White County, Georgia

ADDENDUM # 2

Security Camera System RFP Project# 2019-RFP-PR080919

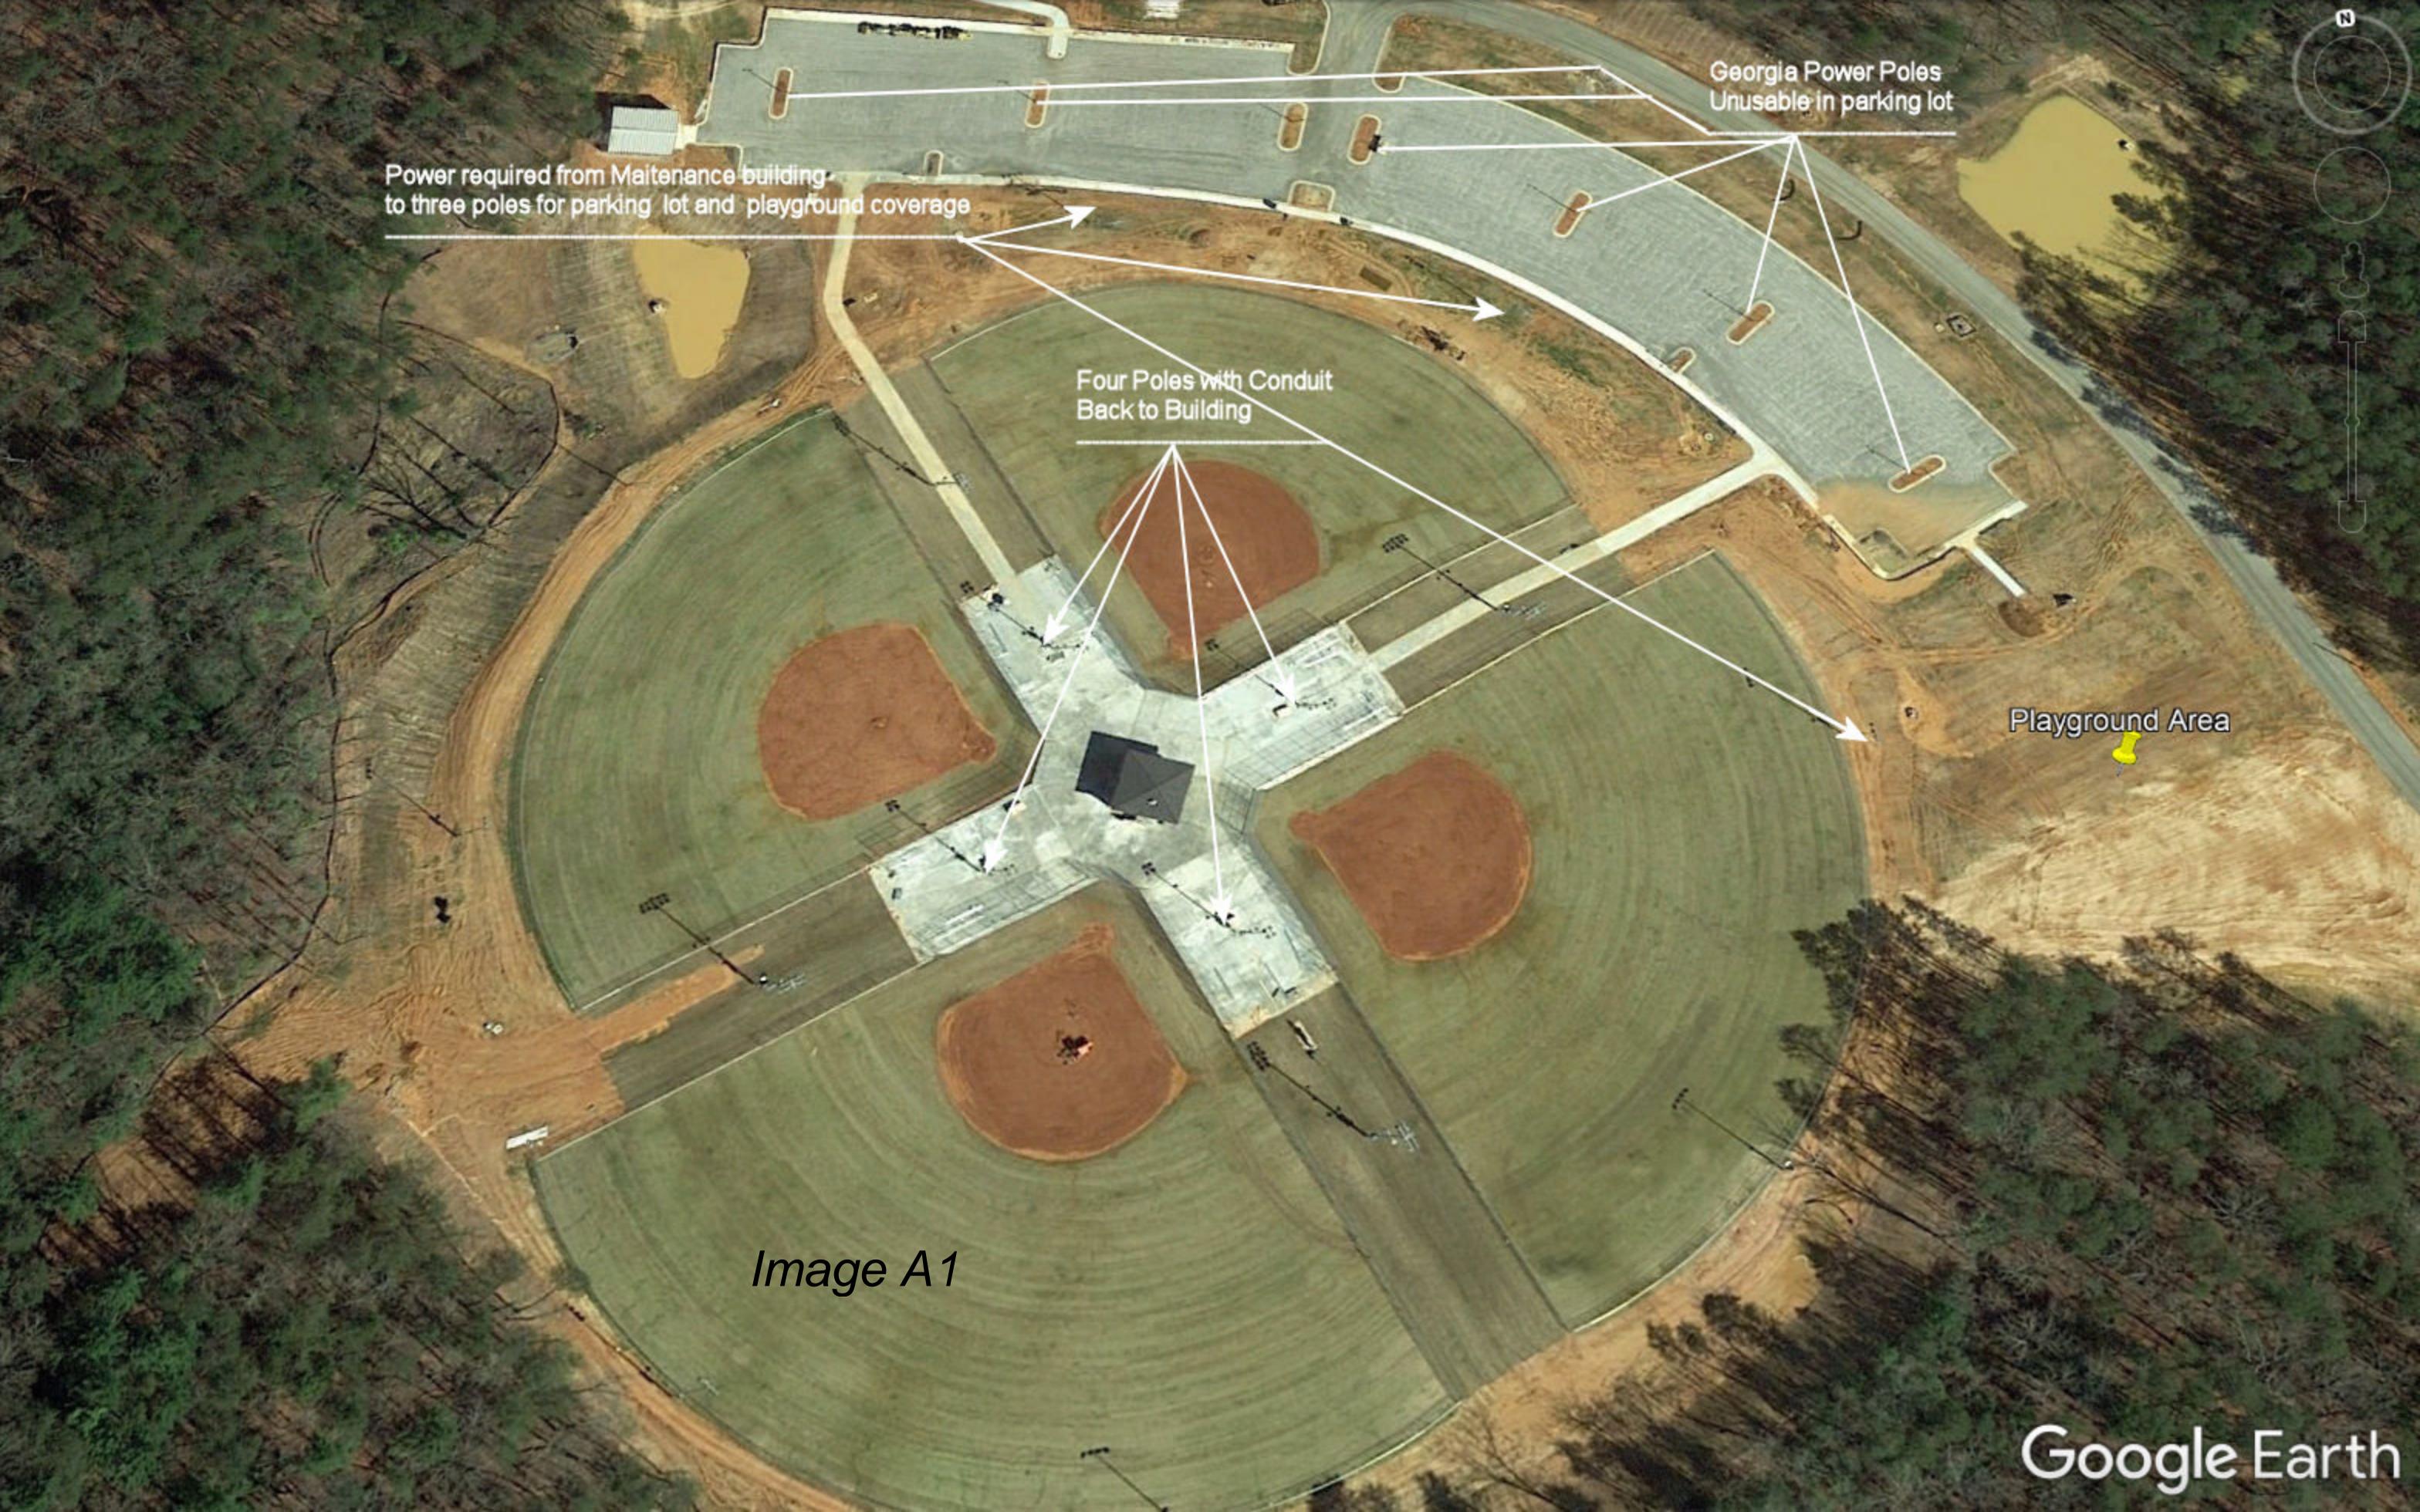
- A. The football field area coverage has been removed from this proposal request. Pricing for this area should not be included in price proposal.
- B. Images of pole sites are part of this Addendum #2 and are attached, A1 and B1.
- C. Georgia Power owned poles will not allow mounting of cameras.
- D. Only poles available for mounting cameras are the four poles near the building with conduit ending inside building and three poles adjacent to the parking lot which will require power. See Image A1. Power will need to be part of the proposal pricing.
- E. For gym area, all cameras must be mounted on building, no poles available. See Image B1.

Q2. Can you please provide us a sketch/google earth map identifying the County Owned pole with the conduit installed to the concession building.

Q7. Is the pole adjacent to the future playground owned by the County or Georgia Power? If it is owned by Ga. Power, will the county erect a new pole for mounting the camera to view the playground? Will the county provide a power source for the remote playground camera, if so what voltage is the power to be provided.

Q8. Can you please provide us a sketch/google earth map identifying the ownership of the light poles near the pool and pickle ball courts

Q12. Can you please provide a sketch/google earth map with the gate shown.

Q14. Can you confirm that the light poles surrounding the baseball fields and the area between the fields and the parking lot are owned by the county and that cameras can be mounted to these poles?

Q15. For the baseball complex parking area and playground area, can you please identify the nearest 110V power source?

Q16. Can you confirm if 110V power is already present at any or all of the light poles situated between the baseball fields and the parking and playground areas?

Q24. Which poles are county owned and can be used for camera/wireless placement?

A2. See attached images, A1 and B1.

A7. See Image A1. Three poles adjacent to the parking lot will require power. Power will need to be part of the proposal pricing.

A8. See attached images, A1 and B1.

A12. See attached images, A1 and B1.

A14. Yes. See attached image A1.

A15. Yes. See attached image A1.

A16. See Image A1. Three poles adjacent to the parking lot will require power. Power will need to be part of the proposal pricing.

A24. See attached image A1.
